ADDENDUM NO. 2

June 7, 2021

**HANOVER COMMUNITY SCHOOL CORPORATION - NEW RESOURCE
CENTER AND RELATED WORK
Cedar Lake, IN 46303**

This Addendum consists of page ADD 2-1 through ADD 2-2 and attached Addendum No. 2 from Gibraltar Design dated June 3, 2021 and consisting of 4 pages, Specification Section 07 42 64 Metal Panel Soffit, Specification Section 07 53 23 Roof Insulation and Membrane Roofing – EPDM, and 43 drawings.

MECHANICS BUILDING ARCHITECTURAL ROOF PLAN
SCALE: 1/16" = 1'-0"

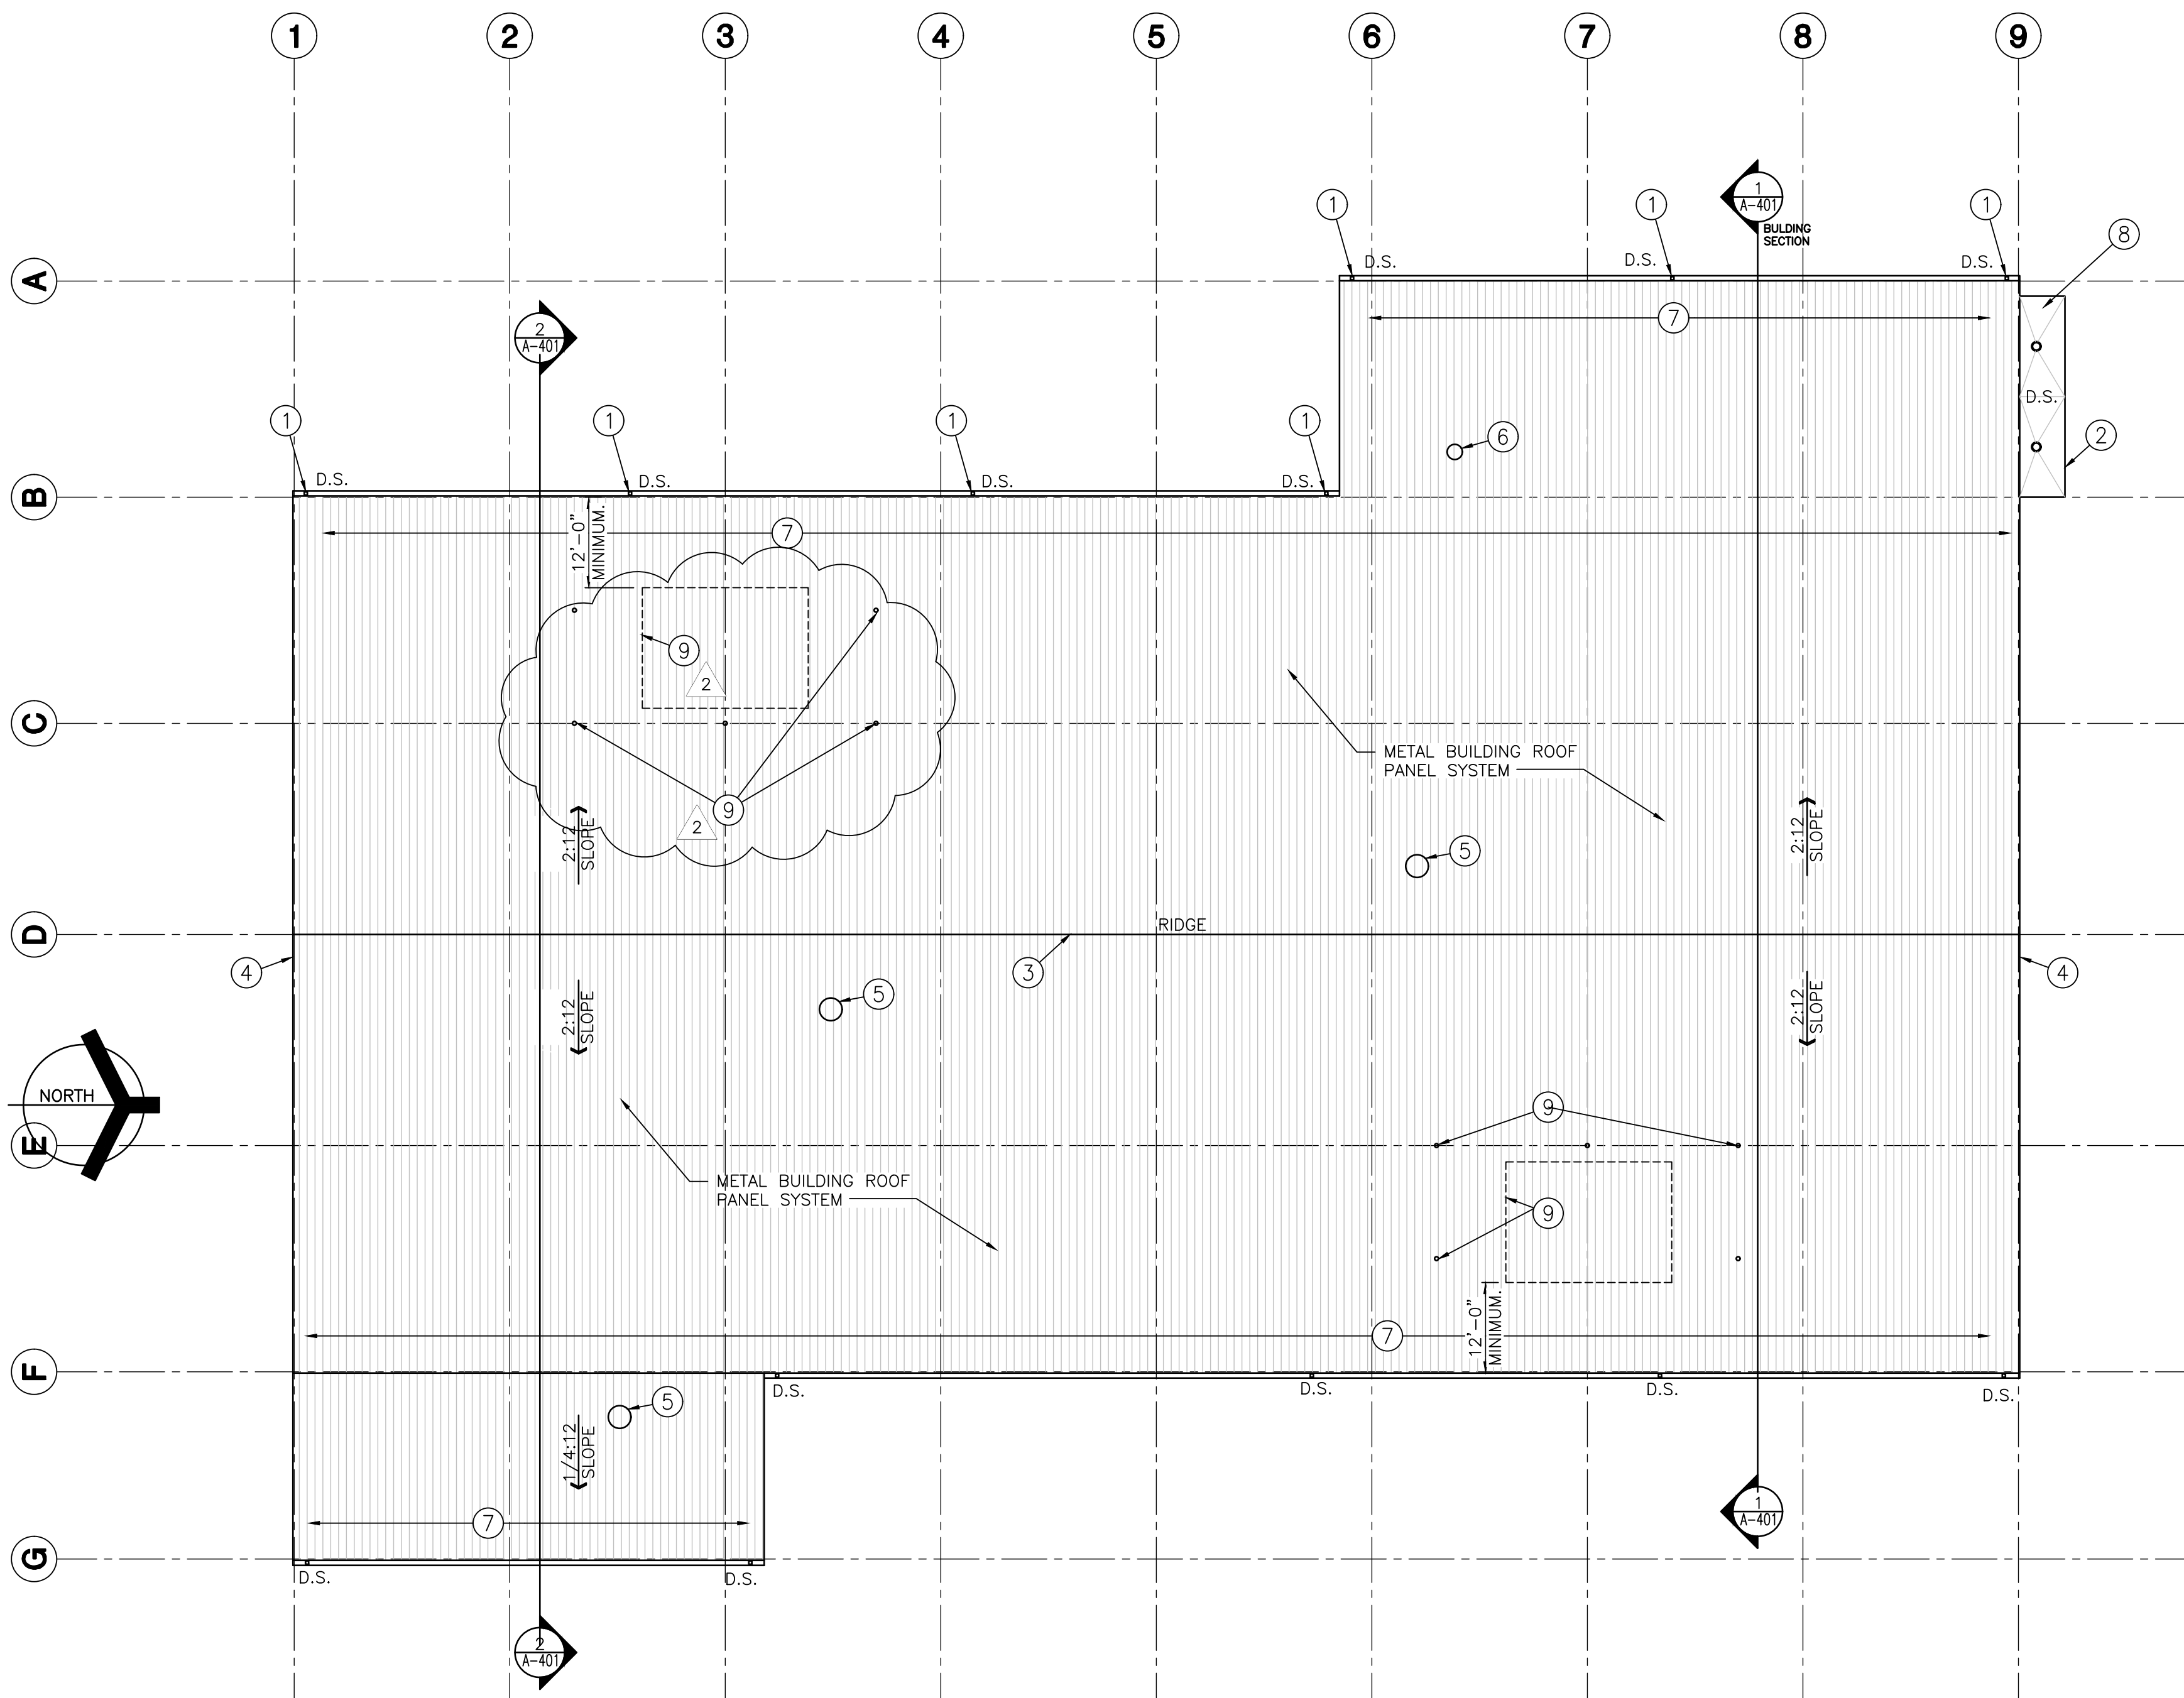
8. Sheet A-201

- A. Refer to revised Full Size Drawing Sheet included in this Addendum for revisions.

GIBRALTAR DESIGN	SHEET P-114
------------------	-----------------------

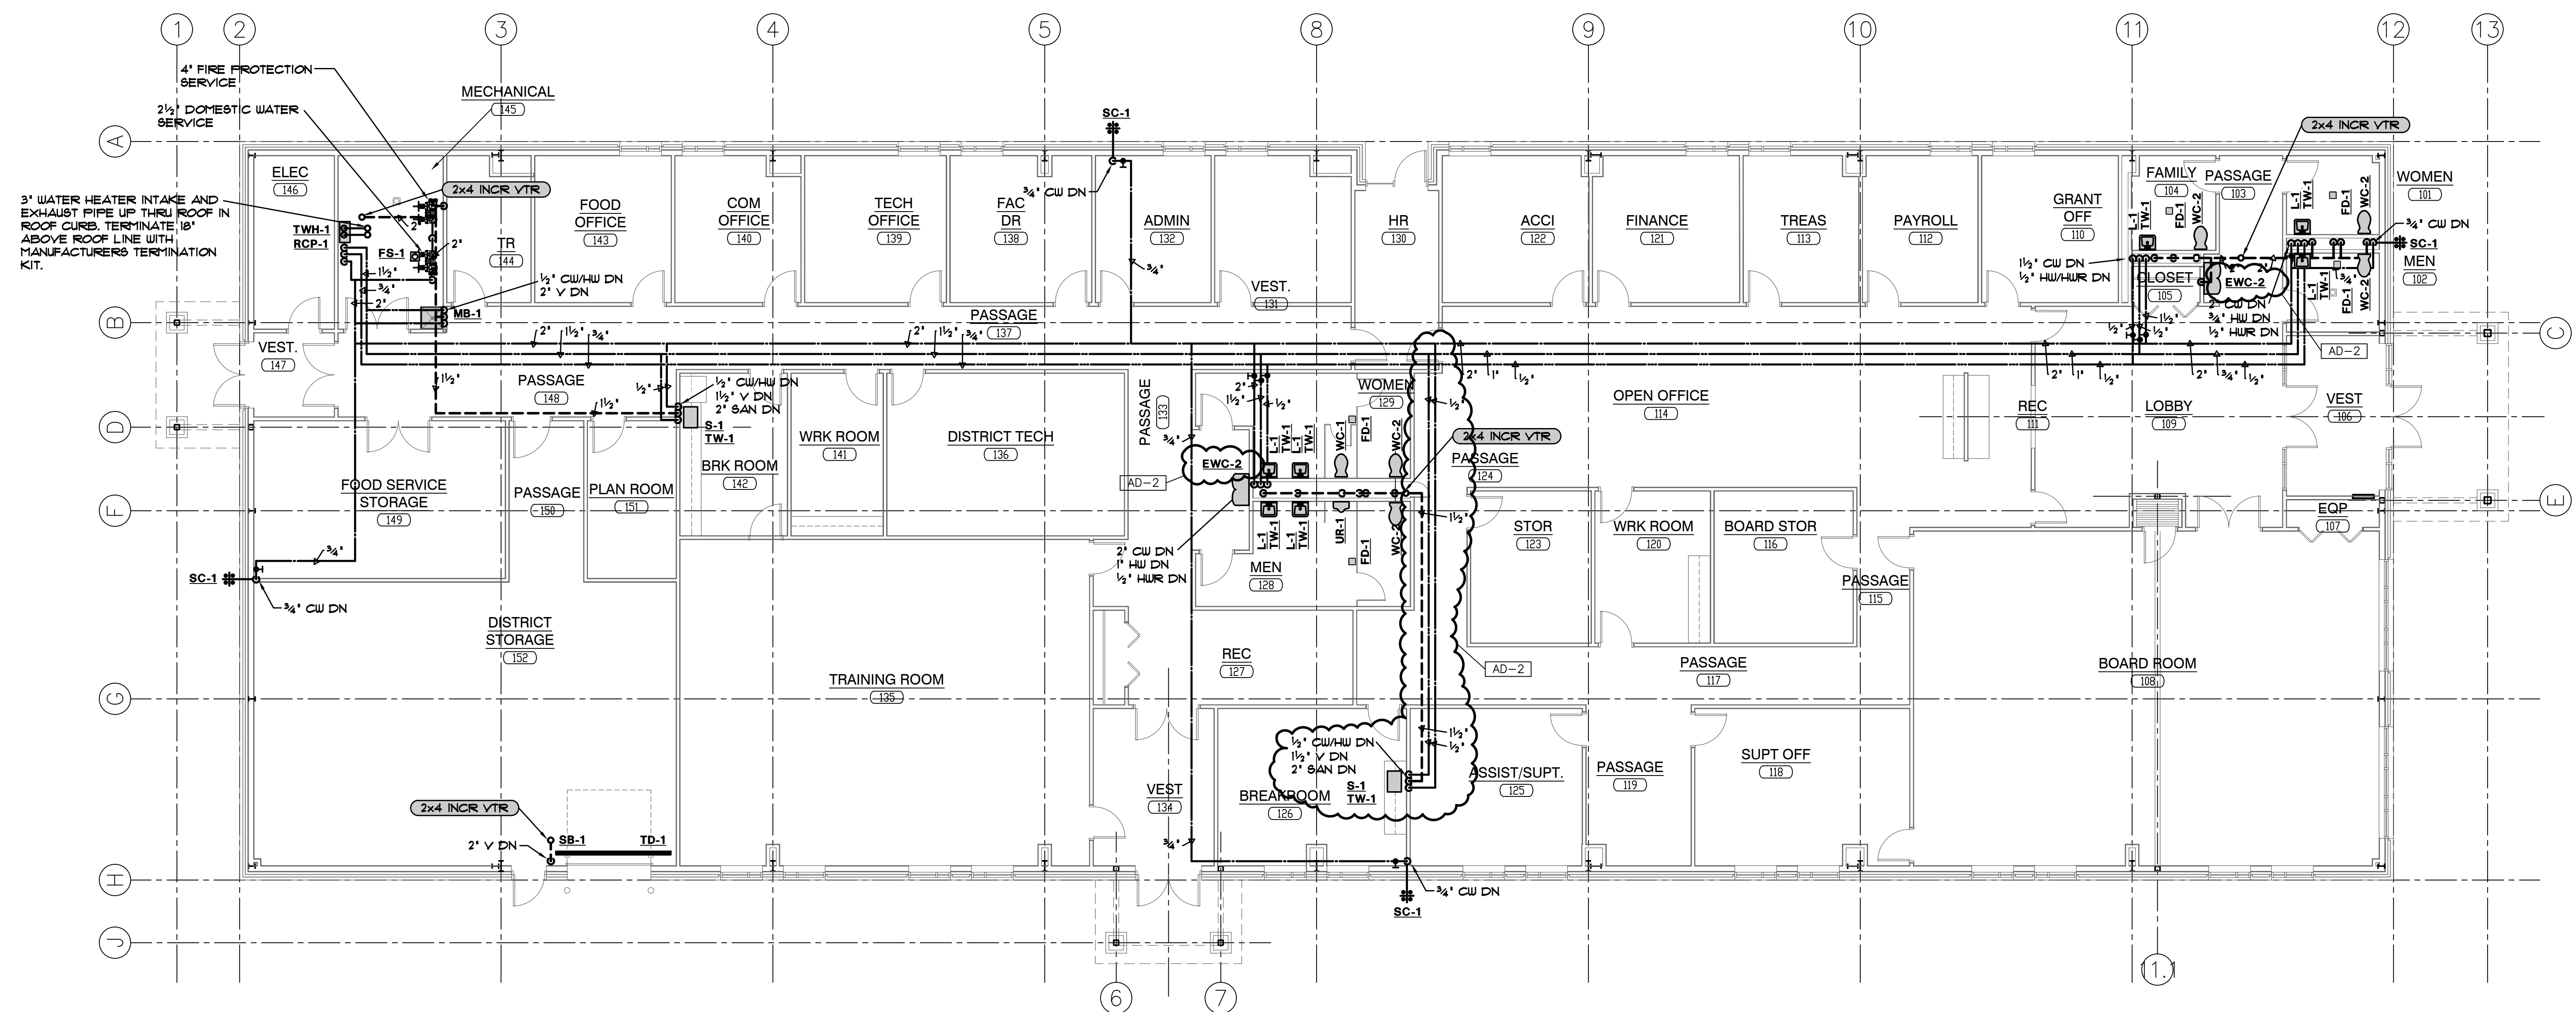
22. Sheet P-114

- A. Refer to revised Full Size Drawing Sheet included in this Addendum for the following revisions:
 - 1. ADDED sink and associated piping. Refer to revised drawing for additional information.
 - 2. REVISED EWC to EWC-2.
